Subject: [EXTERNAL] San Juan 28-6 Unit #125 incident# nRM2030132715

OCD has reviewed the Site Characterization and Remediation Plan for the San Juan 28-6 Unit #125 incident# nRM2030132715 submitted to the OCD on December 30, 2020 and has denied the report due to the following deficiencies:

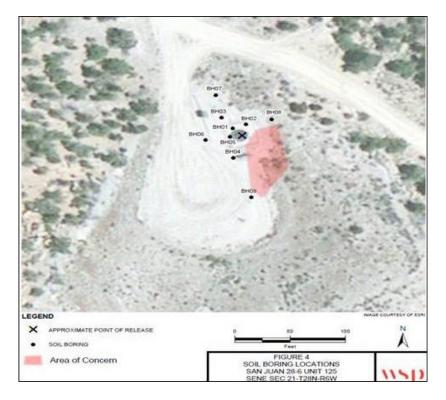
- a. If the proposed borehole location (Blue dot) needs to be changed for any reason, HEC will notify and get OCD approval prior to drilling the delineation borehole

1. Hilcorp plans to advance an additional boring in the approximate location of the blue dot on the attached figure. This location may require adjustment to accommodate drill rig access based on topography, fencing, vegetation, and/or landowner agreement. This boring will be advanced to an anticipated depth of 50 feet below ground surface based on the depth of impact discovered in other onsite borings. Soil samples will be collected from the borehole every foot and field screening will be conducted using a photoionization detector (PID). If field screening results measure greater than 100 parts per million (ppm) at a depth of 50 feet, the boring will be advanced deeper until at least two consecutive PID readings are less than 100 ppm. At least two samples will be collected for laboratory analysis: one sample from the total depth and one sample from the
